COMMENTS

CALIFORNIA UNIONS FOR RELIABLE ENERGY

Preliminary Staff Assessment

Carrizo Energy Solar Farm

Figure 1: Project location in relationship to Carrizo Plain National Monument.²¹⁴

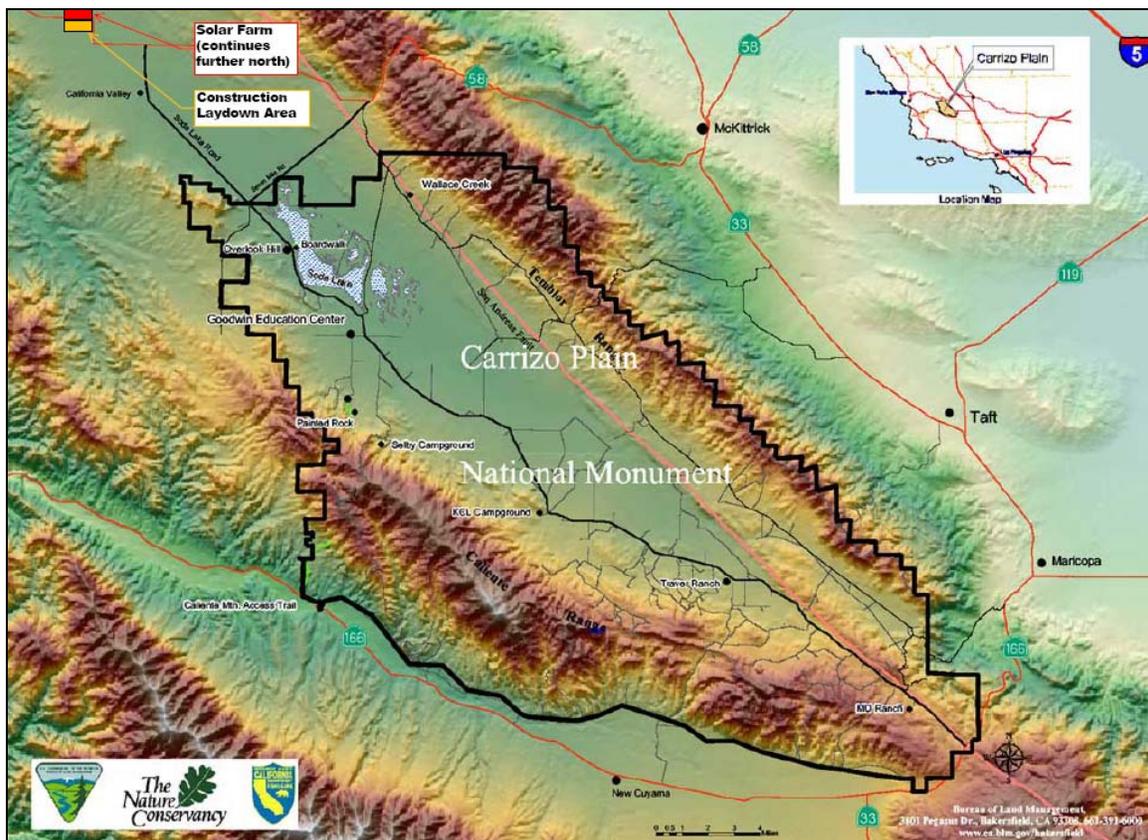
The Project is located in the Carrizo Plains, just northwest of California Valley and within ten miles of the Carrizo Plain National Monument (See Figure 1 below). The Carrizo Plains is a large, enclosed plain, approximately 50 miles long and 15 miles wide. Bordering the plain to the northeast is the Temblor Range, to the west is the La Panza Range, and to the southwest is the Caliente Range. The AFC states that “[t]he general area is characterized as relatively flat allowing for open, expansive views of hills and mountains surrounding the valley.”²¹³ Expansive views of agricultural fields, foothills, and mountain profiles are characteristic of the area, and because the views are largely unspoiled, the Carrizo Plains remain unique.

Figure 5: Simulated view (cropped) of CESF From Key Observation Point No. 3 (West), Carrizo Energy Solar Farm (CESF), Figure No. 2.13-4 in the Supplement to the AFC.

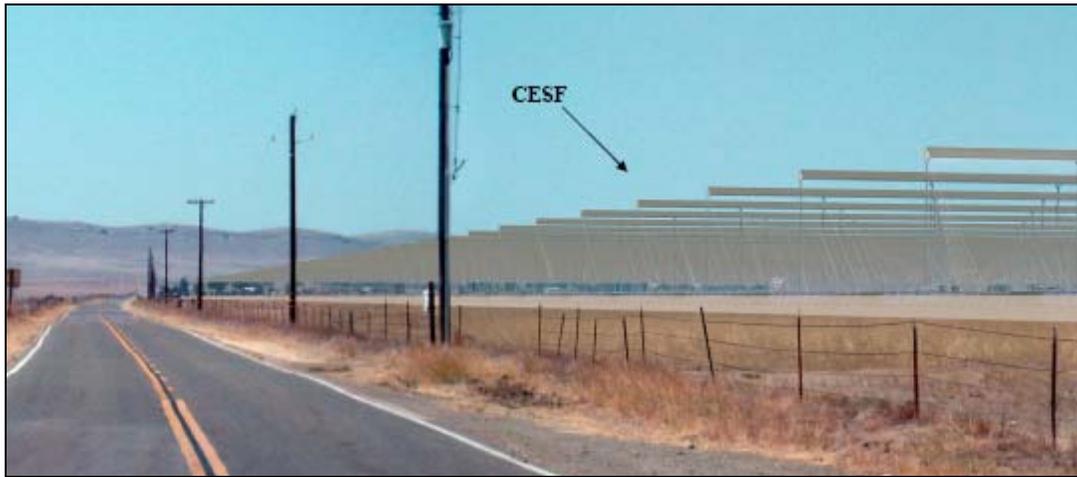
In the simulated view west of key observation point No. 3 (Figure 5), the glare from the underside of the linear collectors appears to be underrepresented when compared to the photograph from the Ausra website (Figure 6). This is particularly concerning when considering the motorists traveling westbound or eastbound on Highway 58 who will gaze in a northerly direction at the linear collectors, and who may be startled or perhaps even temporarily blinded by the glare, as a result.

We recommend that the Applicant provide Staff with information about the graphics software that was used, along with data input files, for independent confirmation of how representative the images would be of the Project upon completion. We also recommend that the Applicant render additional simulated images at key observation points, including motorists' views and views from Highway 58. These observation points should depict conditions at different times of the day and during different seasons. This information is key to Staff's assessment of the potentially significant visual impacts posed by the Project, particularly the glare that motorists will encounter.

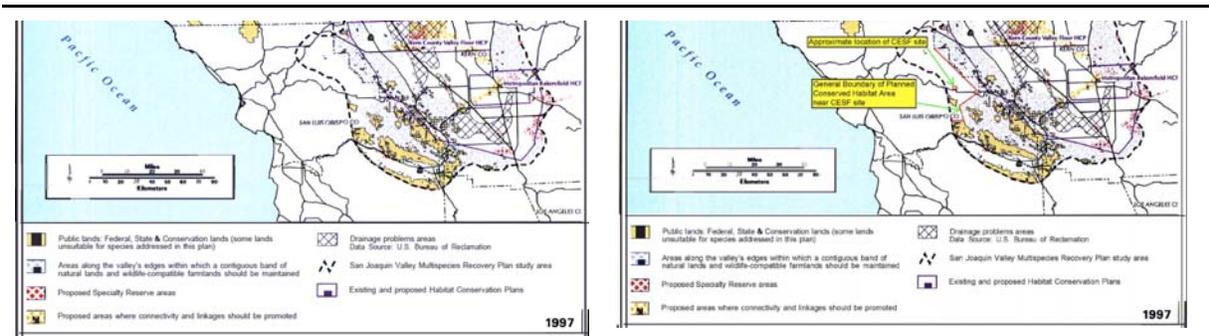
Importantly, Staff should be aware that the Upland Recovery Plan uses stippled gray to depict those areas along the valley's edge within which a contiguous band of natural lands and wildlife-compatible farmlands should be maintained (see figure below).²⁷⁶ Figure 3 of the Applicant's 2008 Biological Surveys Report is nearly identical and is presumably intended to depict the same areas (see below). However, the figure contained in the Applicant's survey report has a red boundary line added to depict "the general boundary of planned conserved habitat area near CESF site." This red line could easily be interpreted as a recovery plan boundary, with the Project site outside some "conserved habitat area." We advise Staff that the original figure in the Upland Recovery Plan does not contain the boundary line depicted by the Applicant. In fact, there is no such boundary or area discussed in the Upland Recovery Plan. Instead, the Project area is completely within the recovery planning area.
